#2018-114 903 North Shore – Variation Project Review for Planning and Zoning Commission

<u>Meeting Date:</u>	October 3, 2018
<u>Request:</u>	To encroach 7.8 feet into the average 51.3-foot front yard setback (lake side) to construct an addition with second story and projecting balcony.
<u>Location:</u>	903 North Shore
<u>Acreage:</u>	Approximately 7,500 square feet
<u>Existing Zoning:</u>	R-2 Single Family
<u>Surrounding Properties:</u>	North: W Watershed South: Crystal Lake East: R-2 Single Family West: R-2 Single Family
<u>Staff Contact:</u>	Elizabeth Maxwell (815.356.3615)

SITE PLAN

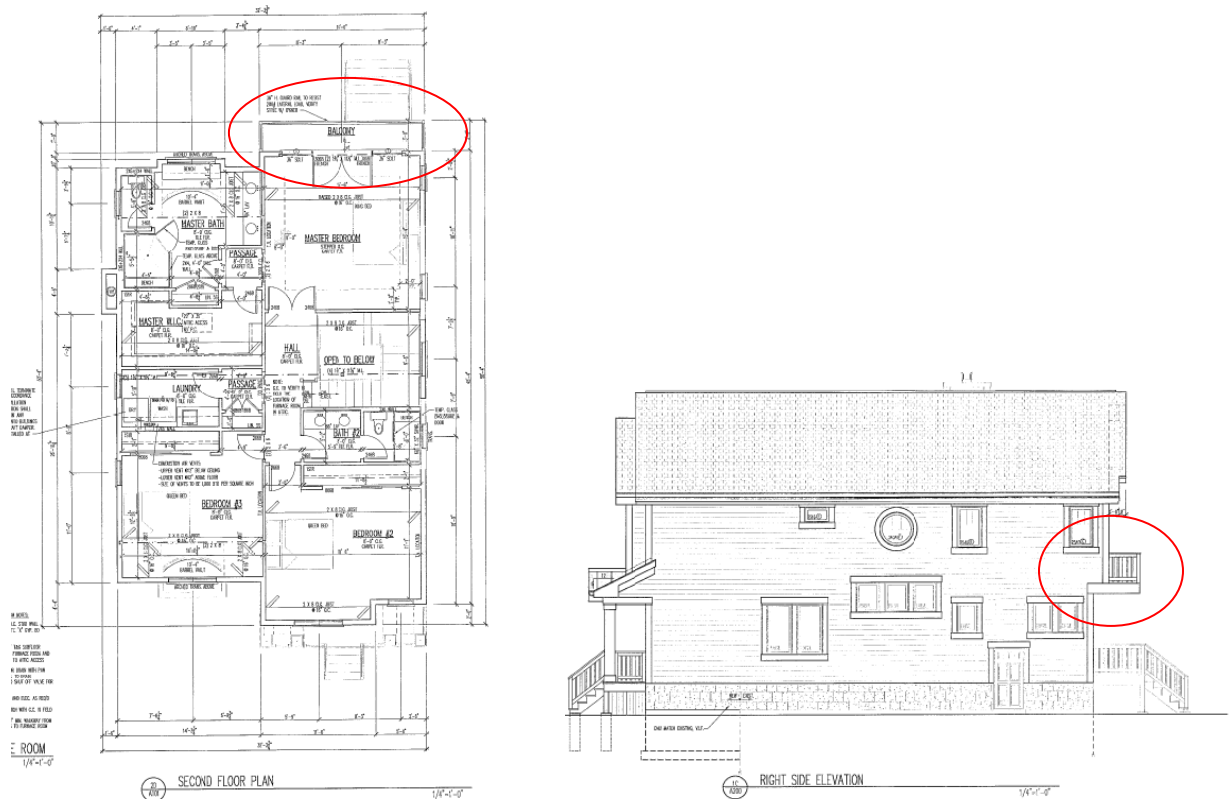
- The existing home has a partial second story, which would be increased to a full second story with the proposed construction. There is also a proposed addition and front porch on the street side of the house, neither of which are in the setback. On the lake side of the home there is a proposed projecting balcony from the master bedroom towards the lake.

- A portion of the second story and the balcony are within the required averaged front yard setback (lake side). The average front yard setback is generated using the existing setback of the homes within 400 feet, typically 200 feet on either side of the property in question.
- The setback was determined to be 51.3 feet. The house is currently setback approximately 46 feet.
- The previous owner constructed a paver patio with seat wall. The petitioner is required to provide an updated plat of survey with the new patio illustrated.
- The photo below shows the existing layout of the home and the patio.

FRONT ELEVATION
REAR ELEVATION
LEFT SIDE ELEVATION
RIGHT SIDE ELEVATION

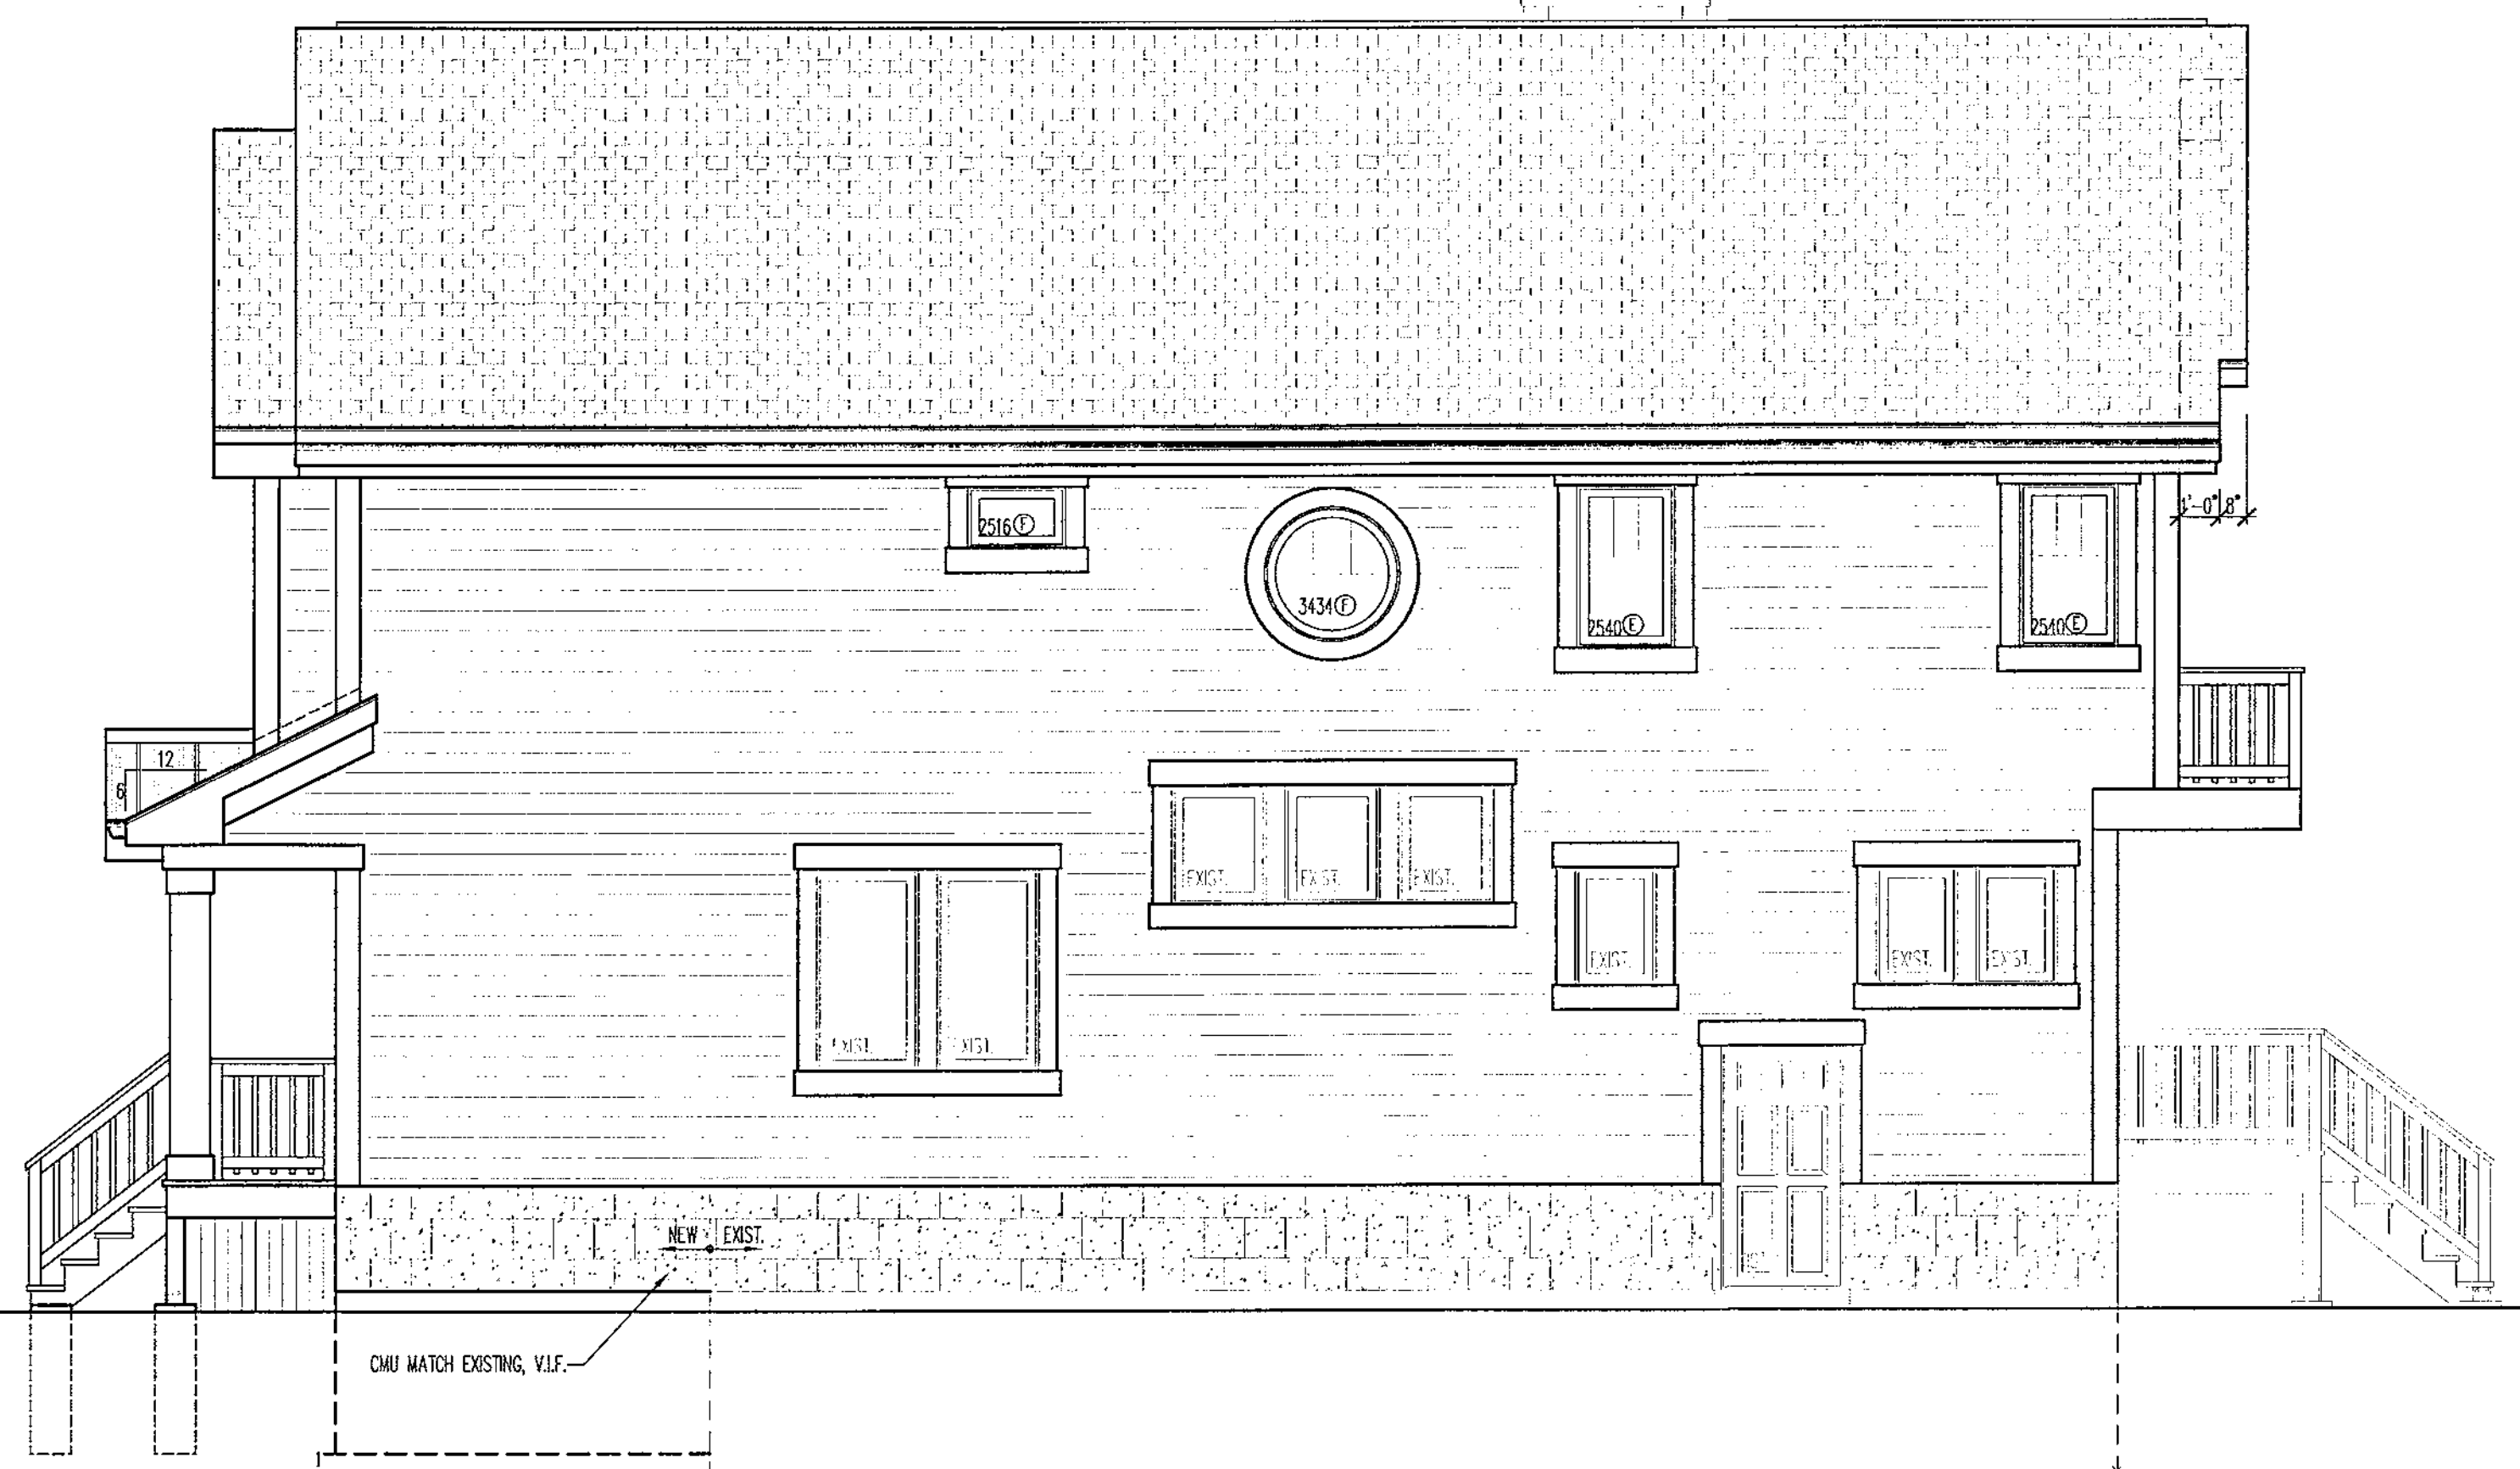
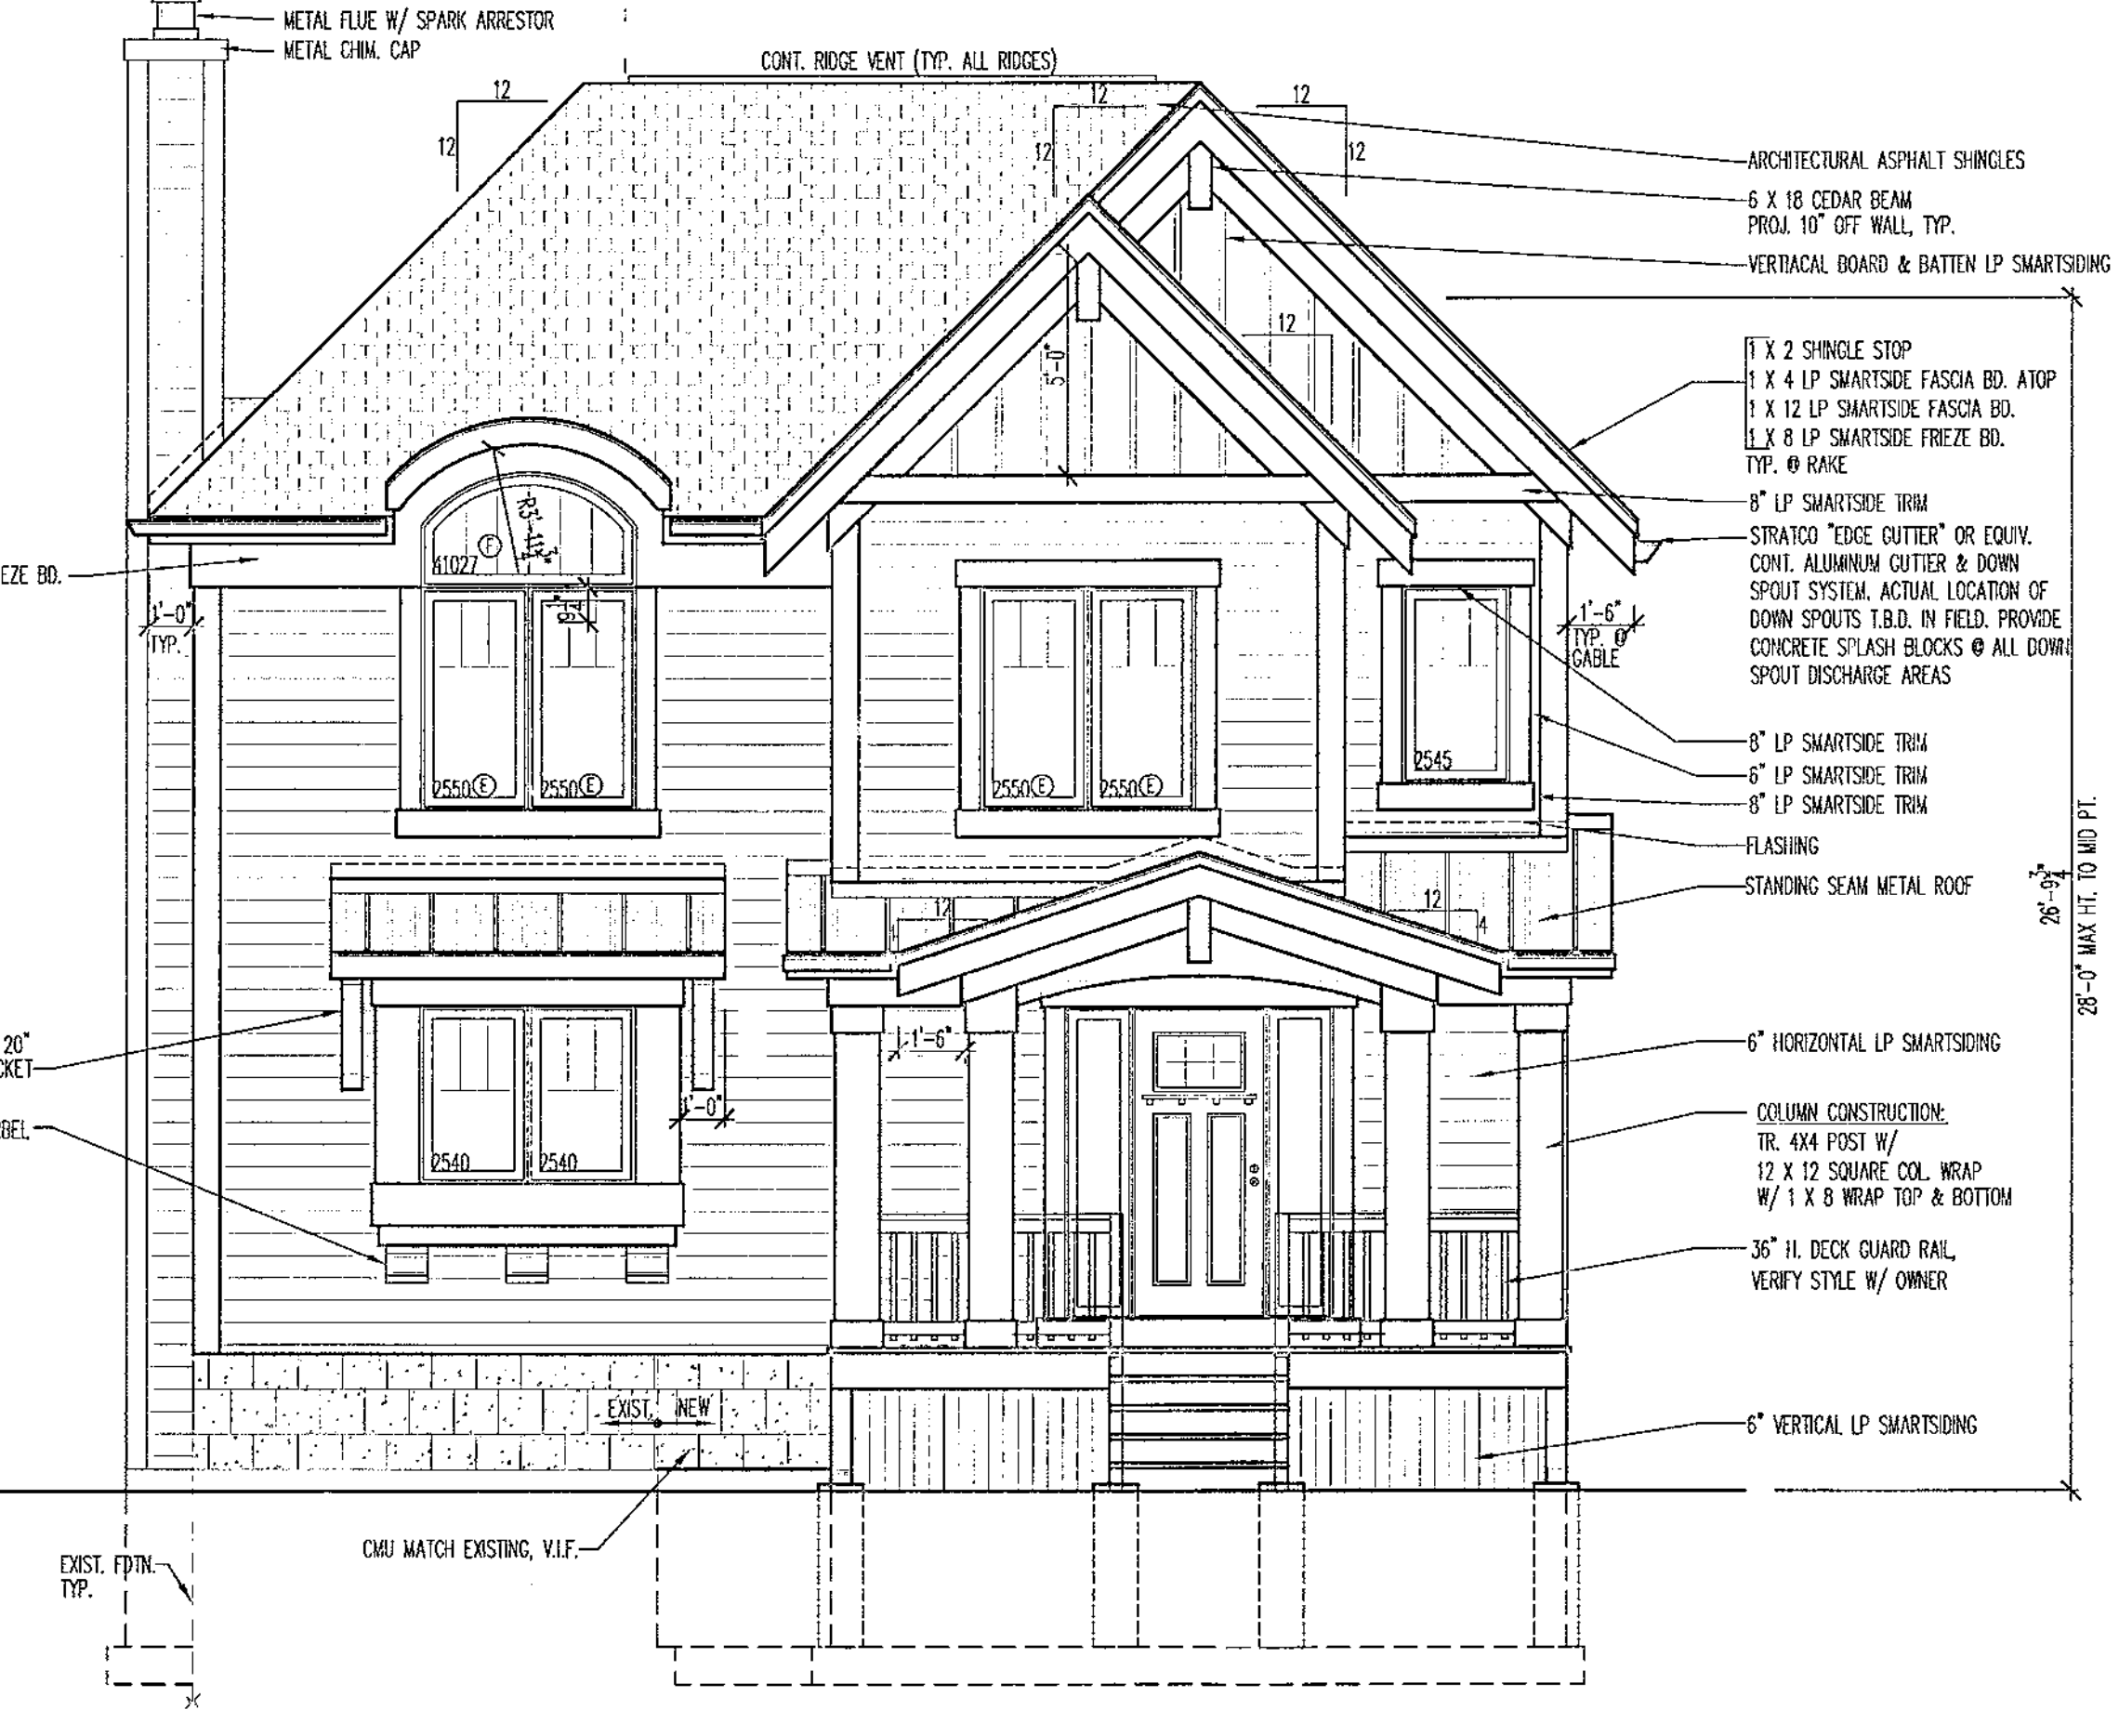
- The changes to the façade will bring a much needed improvement to the character of the neighborhood.
- The new elevations will comply with the Design Standards.
